**BOWERS ELEMENTARY SCHOOL
MANCHESTER, CONNECTICUT
STATE PROJECT NO. 077-0239 RNV
ADDENDUM NO. 7
March 2, 2022**

I. REVISIONS TO SPECIFICATIONS

A3.02

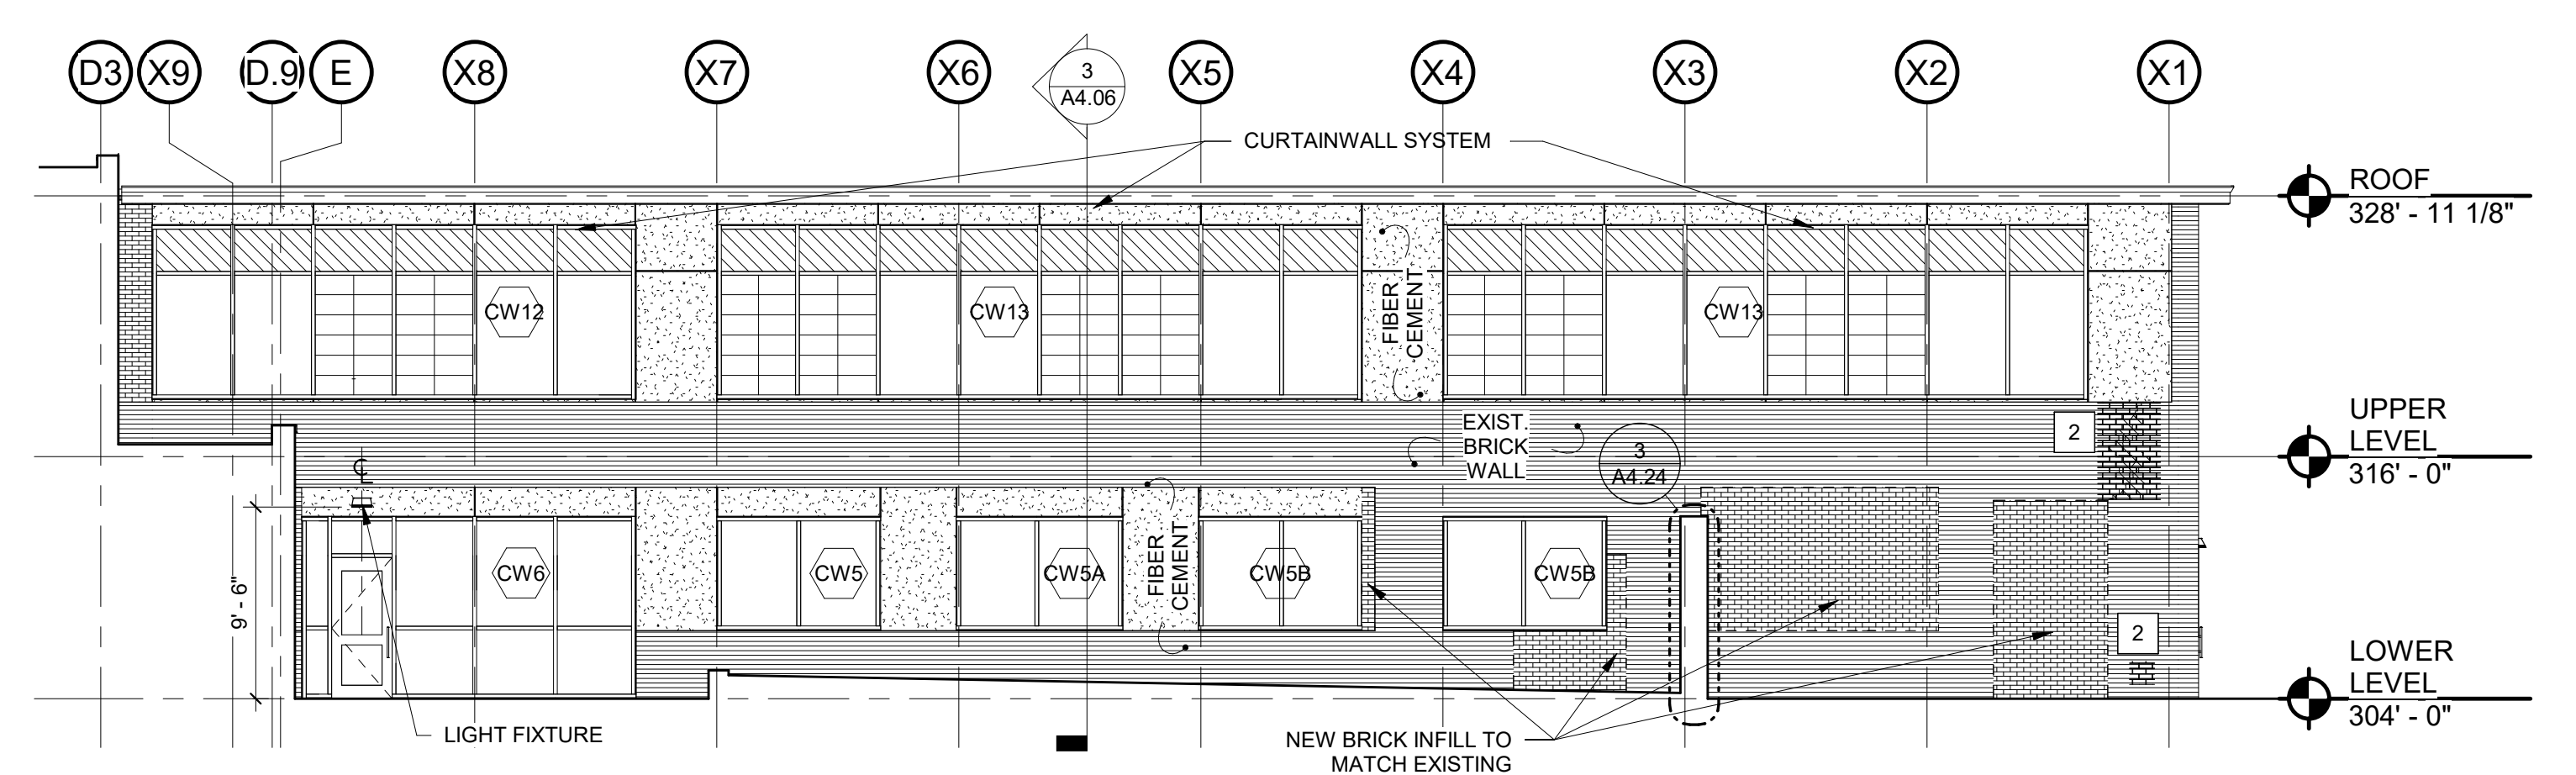
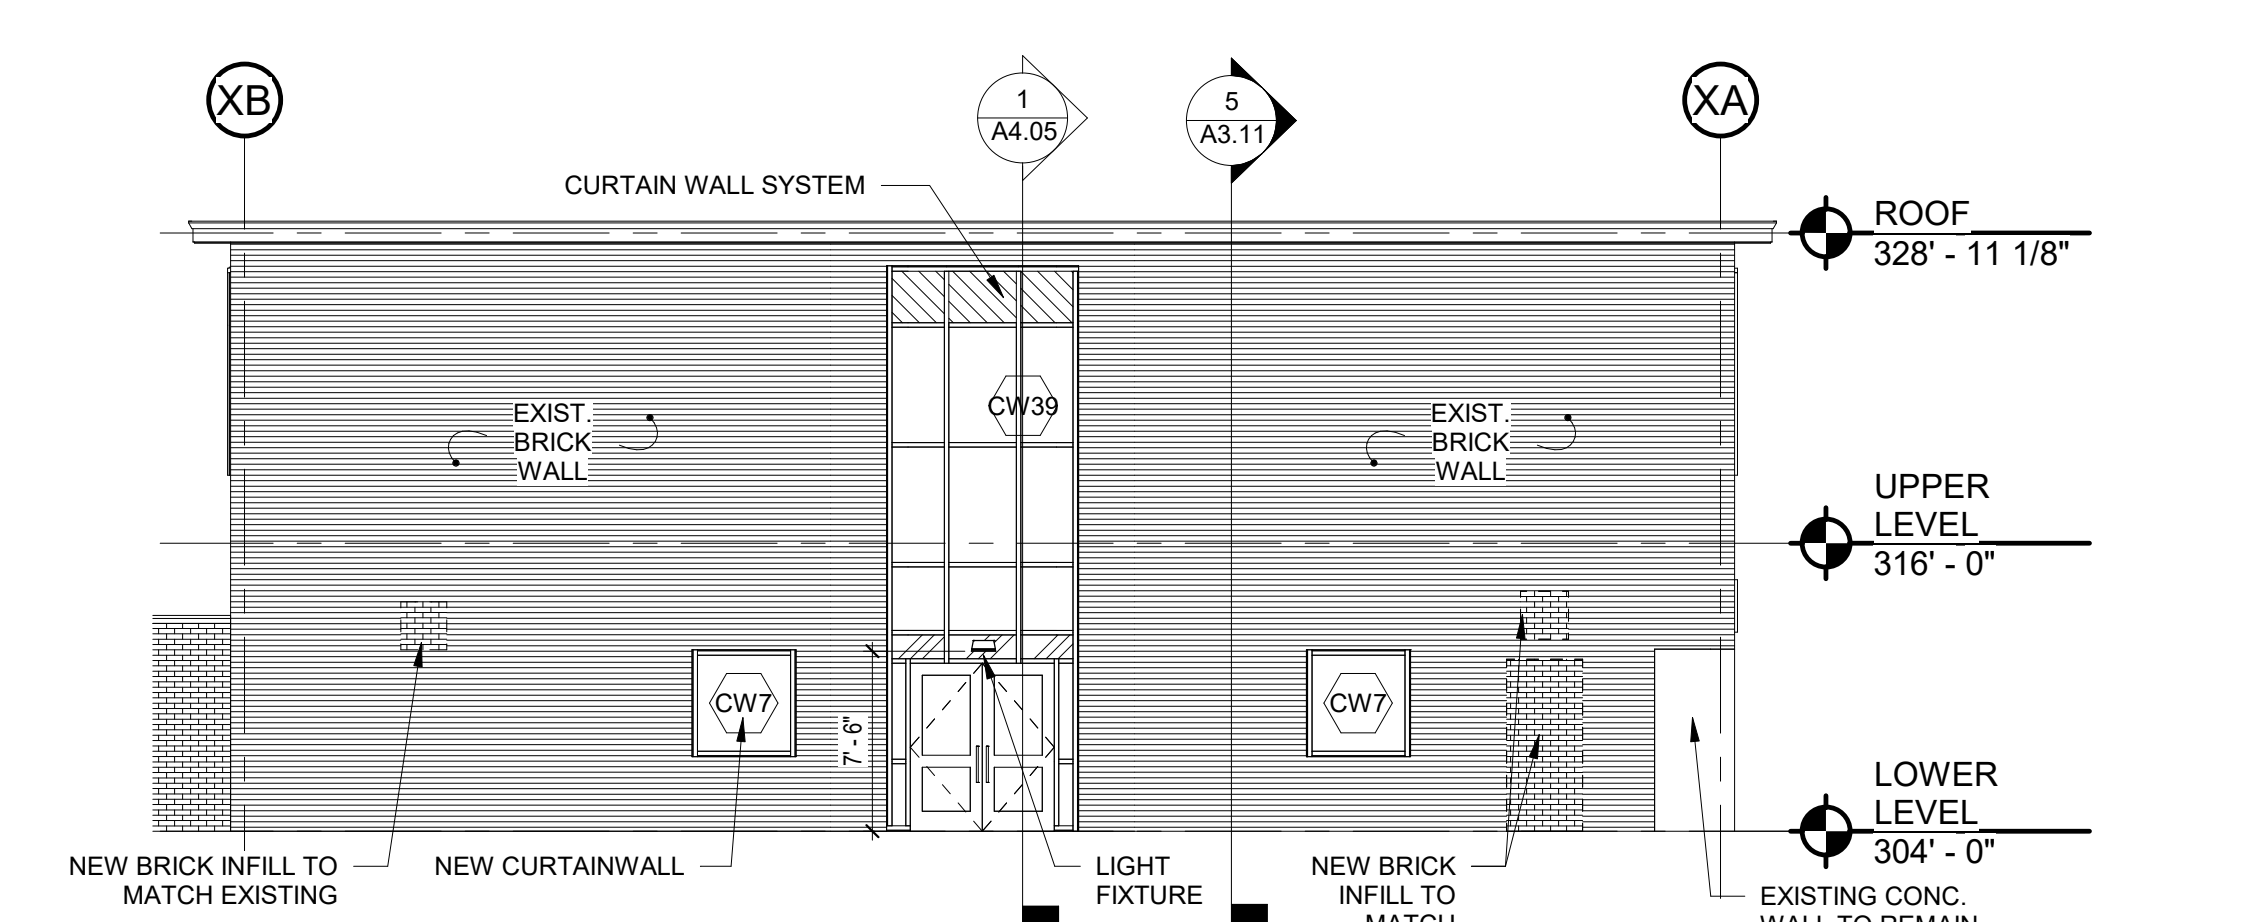
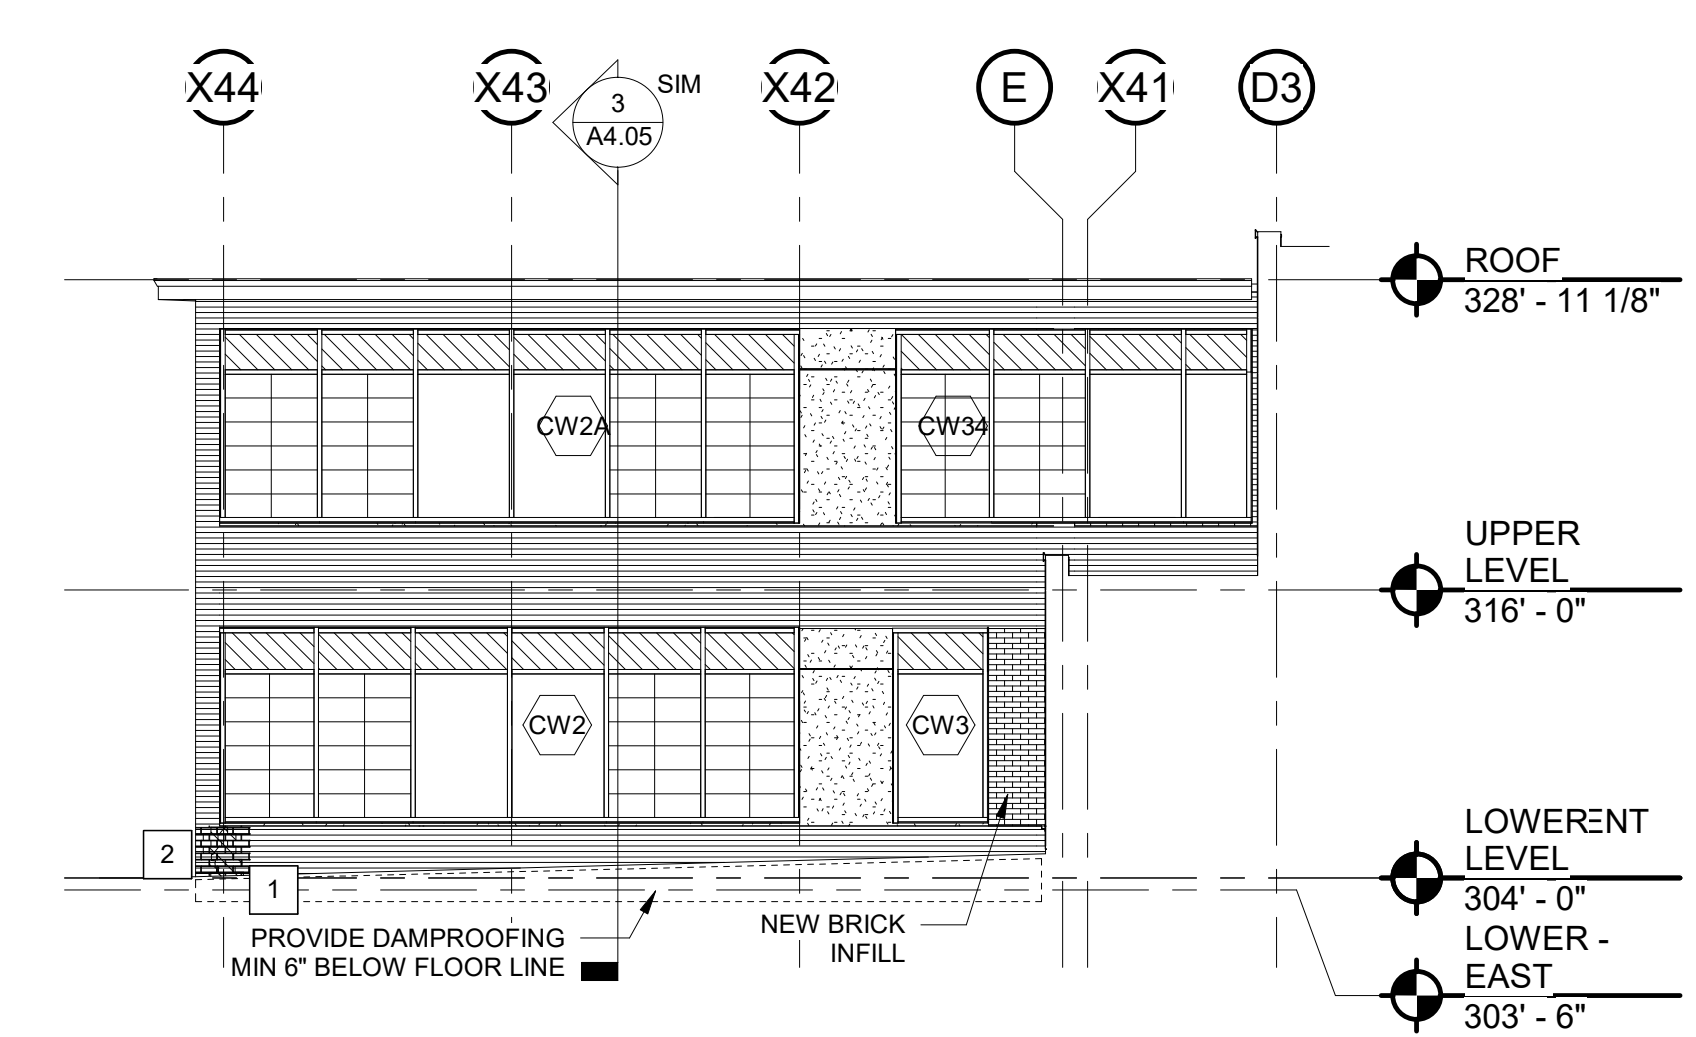
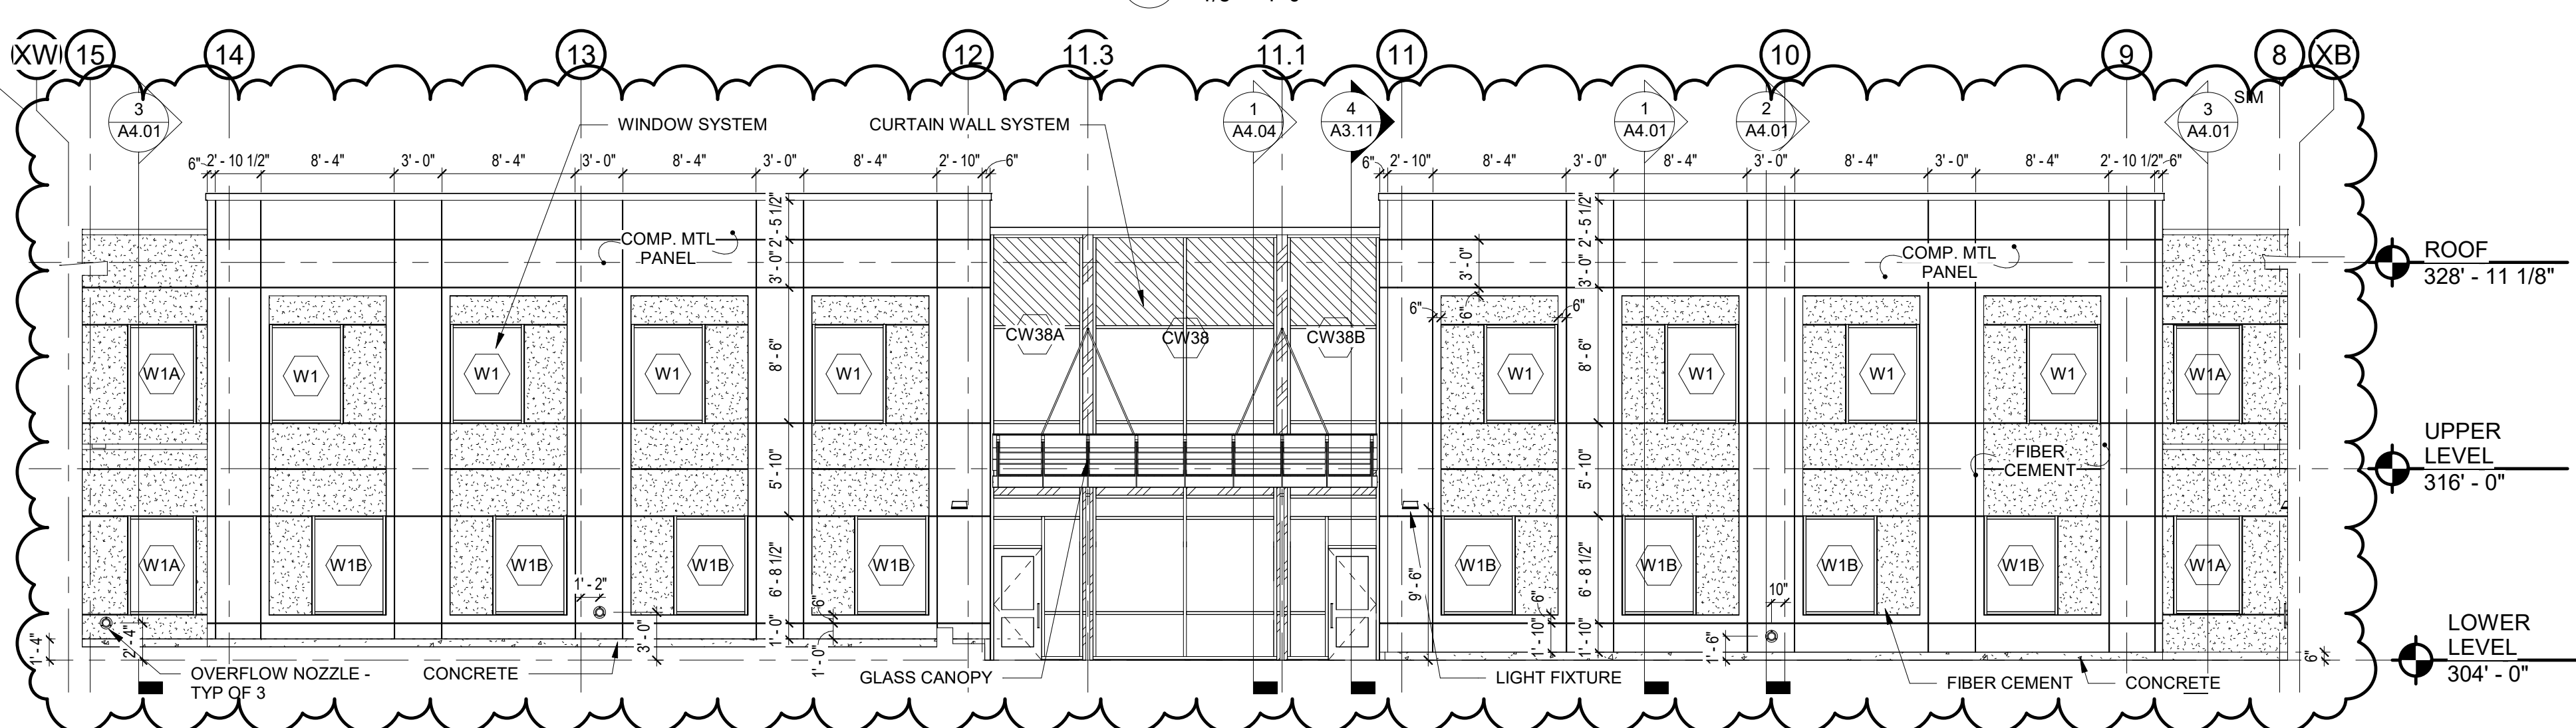
3. A1.01B:
 - Extend railing along north wall of east entrance stair as shown on sketch PB_SKA-09.
4. A3.02;
 - Replace sheet with attached A3.02.
5. A3.03
 - Elevation 8; Revise per PB_SKA-09.
6. A3.11
 - Section 2; Revise per PB_SKA-09.
